Rep No. B17061

Fuji Electric FA Components
& Systems Co., Ltd.

Notification Regarding Change to Printing Specification, Standard No. on CP30F Series Circuit protectors

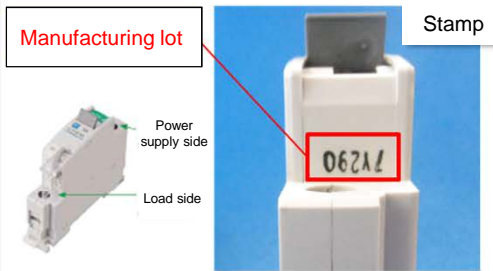
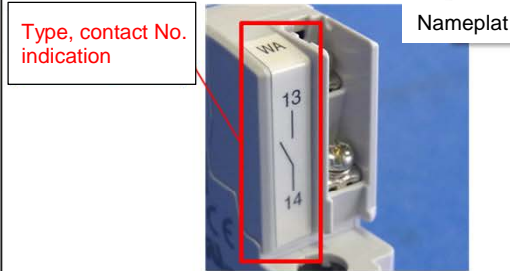
Product name	Circuit Protector
Series name	CP30F Series
Type	CP30FS-1P, CP30FS-2P, CP30FS-3P, CP30FM-1P, CP30FM-2P CP30FM-3P, CP30FI-1P, CP30FI-2P, CP30FI-3P
Changed parts	(1) Case printing specification, (2) Option accessory nameplate, (3) Individual packing boxes, (4) Rating nameplate printing specification
Details of the change	(1) The method used to indicate the manufacturing lot on the power supply side has been changed from stamp printing to laser printing. (2) The option accessory type and contact No. indication has been changed from a nameplate to laser printing. (3) The individual packing box GB standard No. has been changed from GB17701 to GB/T17701. (4) On products with delay device, a "D" has been added to the type indication on the front of the product.
Reason for change	(1), (2) To make identification easier (3) Due to Standardization Administration of The People's Republic of China policy change (switch from GB standard to GB/T standard) (4) To make type identification easier

[Attachment 1] Change to Power Supply Side Manufacturing Lot and
 Option Accessory Nameplate Printing Method

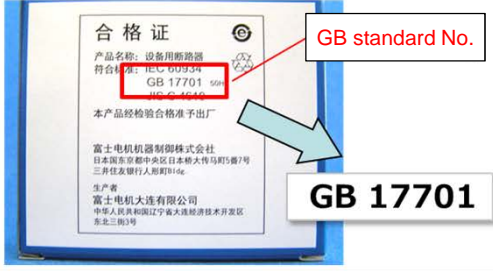
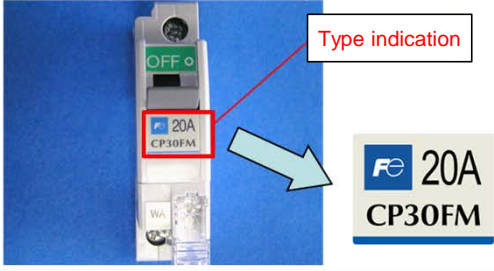
Changed	(1) Case printing specification	(2) Option accessory nameplate
Details of the	The method used to indicate the manufacturing	The option accessory type and contact No.
Reason for	To make product manufacturing lot	To make type, contact No. identification easier
Before change		
After change
